Title of Change:	NCV7428 Datasheet Update (editorial changes)
Effective date:	19 Jul 2023
Contact information:	Contact your local onsemi Sales Office or Jelle.Genne@onsemi.com
Type of notification:	This Product Bulletin is for notification purposes only. onsemi will proceed with implementation of this change upon publication of this Product Bulletin.
Change Category:	Datasheet Update (editorial changes)
Change Sub-Category(s):	Datasheet/Product Doc change

Datasheet update from Rev. 7 to Rev. 8
 The change will not impact form, fit, or function of the products.

From	To
Datasheet	NCV7428/D, Rev. 7	NCV7428/D, Rev. 8

Case outline information page updated as per FPCN22120ZC

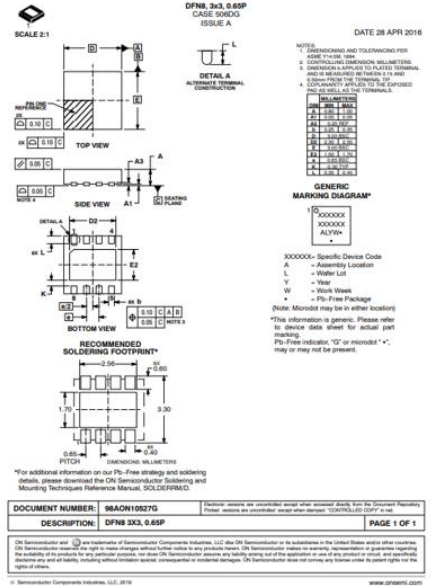
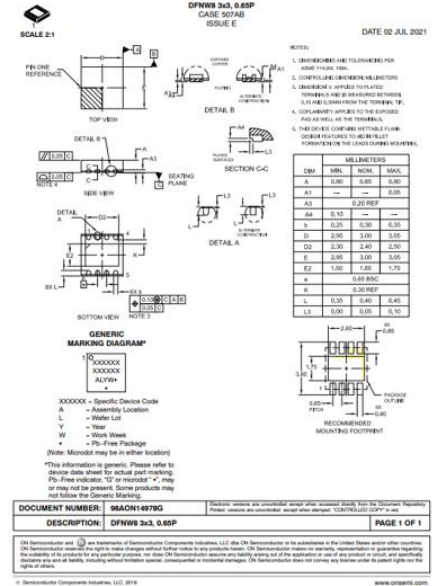
Case outline information: Updated from 506DG to 507AB as per FPCN22120ZC (switchover DC = 2311).
